PLANNING REPORT

PLANNING AND ZONING COMMISSION

SEPTEMBER 18, 2008

4. Tartan Ridge – Text Amendment & Entry Feature Hyland-Croy Road 08-082AFDP Amended Final Development Plan

PROPOSED ENTRY FEATURE

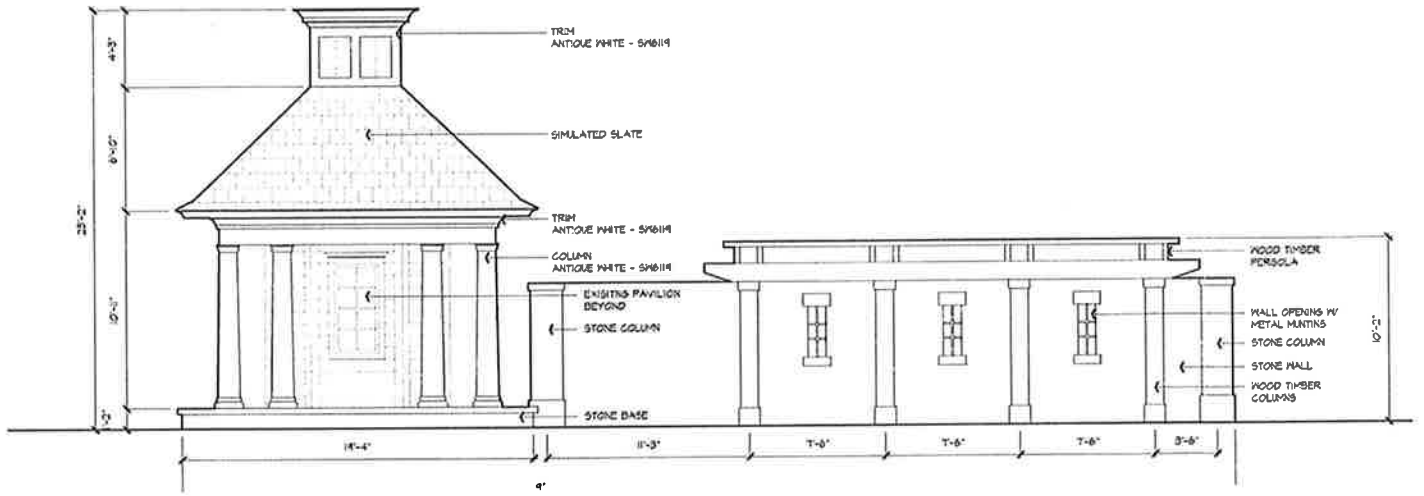
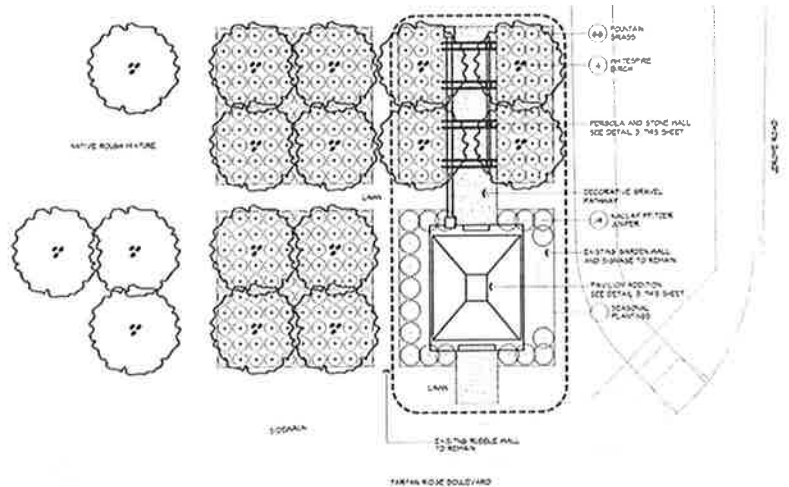
The applicant wishes to revise the pavilion to incorporate columns and a new roof with a cupola, slightly increasing its footprint and height. A decorative gravel pathway is proposed to run to the north through the entry. An approximately eight-foot tall stone wall with a pergola and columns is proposed to add a more formal look. The existing sign will remain.

Criteria met. The proposed modifications to the entry feature add an additional pedestrian path through the plantings along Jerome Road. Safety of pedestrian or vehicles is not affected by the modification. No changes to lighting are proposed.

Criteria met. No changes are proposed to the sign and the revised entry feature does not interfere with the natural characteristics of the site. The increase in the footprint of the entry feature is insignificant to the storm drainage on the site.
